Adequacy of Consultation Representation Proforma

Project name	East Midlands Gateway Phase 2
Date of request	22 October 2025
Deadline for AOCR	31 October 2025
Return to	Emgateway2@planninginspectorate.gov.uk

**East Midlands Gateway Phase 2 (EMG2)
Response to Statutory Consultation**

**East Midlands Gateway Phase 2 (EMG2)
Response to Statutory Consultation Response**

M1 Junction 24 improvements

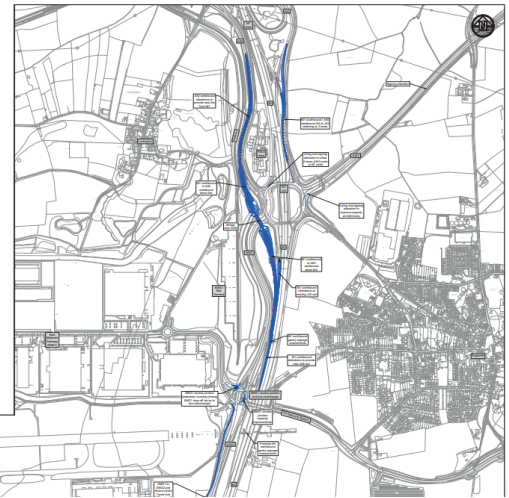
In respect of our concerns with the exhibition boards, this relates to board 6 as copied below:

Of particular concern is the final paragraph which states that modelling demonstrates that the works shown within the drawing would provide significant relief to junctions on the network and accommodate traffic from EMG2. As below, this modelling work remains outstanding, and therefore the board is misleading in this regard.
